Access Compliance Report

Public Rights-of-Way

Intersection ID: 48460	Main Street: TARPWAY_RD	Cross Street: PANGLEMONT_DR	Location: NE
ADA ID: ED19A449EEC6	Ramp Type: PerpDiag	Initial Pass/Fail: Fail	Overall Compliance: No
			Severity Score: 33.75

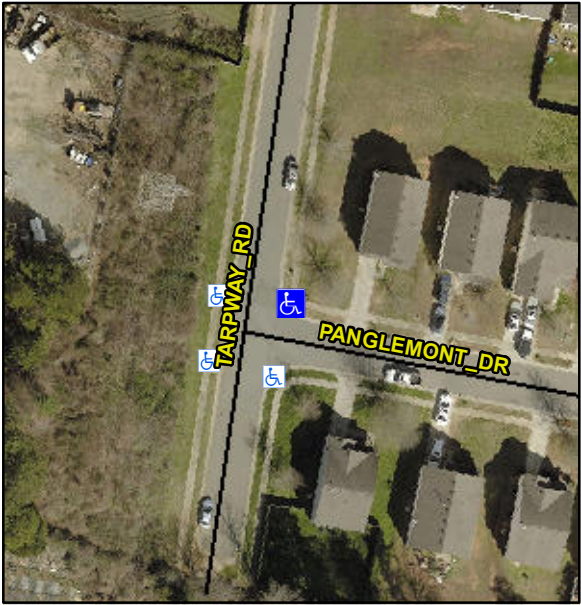
Codes/Mitigation Info/Possible Solution			Field Measurements/Component Compliance		
	Possible Solutions:		Compliance	Description	Data
	Remove & Replace Curb Ramp With Two New Directional Ramps or Equivalent.		N/A	Ramp Length (in)	48.0
			No	Ramp Width (in)	43.0
			N/A	Flare Type LT	N/A
			N/A	Flare Slope LT (%)	N/A
			N/A	Flare Traversable LT?	N/A
			N/A	Landing Length (in)	N/A
			N/A	Landing Width (in)	N/A
			N/A	Landing Slope (%)	N/A
			N/A	Landing X Slope (%)	N/A
			N/A	Landing Curb? (Y/N)	N/A
			N/A	Shared Landing?	N/A
			N/A	Gutter Ponding?	N/A
			N/A	Gutter Lip Ht (in)	N/A
			N/A	Painted X Walk1?	No
				X Walk 1 Direction	To W
			N/A	X Walk 1 Width (in)	N/A
				X Walk 1 Slope (%)	7.0
				X Walk 1 X Slope (%)	3.0
			N/A	Ramp inside XWalk1?	N/A
<p>Surveyor Notes:</p> <p>N/A</p> <p>PROW/ADA:</p> <p>Not Found, R304.5.1, R304.5.3</p>			N/A	Flare Type RT	N/A
			N/A	Flare Slope RT (%)	N/A
			N/A	Flare Traversable RT?	N/A

N/A	DWS Provided?	N/A
			N/A	DWS Contrast?	N/A
			N/A	DWS Length (in)	N/A
			N/A	DWS Full Width?	N/A
			N/A	DWS Offset (in)	N/A
			N/A	Gutter Slope (%)	N/A
			N/A	Gutter X Slope (%)	N/A
			N/A	Painted X Walk2?	No
				X Walk 2 Direction	To S
			N/A	X Walk 2 Width (in)	N/A
				X Walk 2 Slope (%)	2.1
				X Walk 2 X Slope (%)	10.0
			N/A	Ramp inside XWalk2?	N/A
			N/A	Clear Space?	N/A
			N/A	Clear Space to XWalk (in)	N/A
			N/A	Storm Grate/Utility Hazard?	N/A
				Storm Grate/Utility Type	
			N/A		N/A
			Yes	Surface Condition? (G/P)	Good
Total Cost:		\$ 3200.00
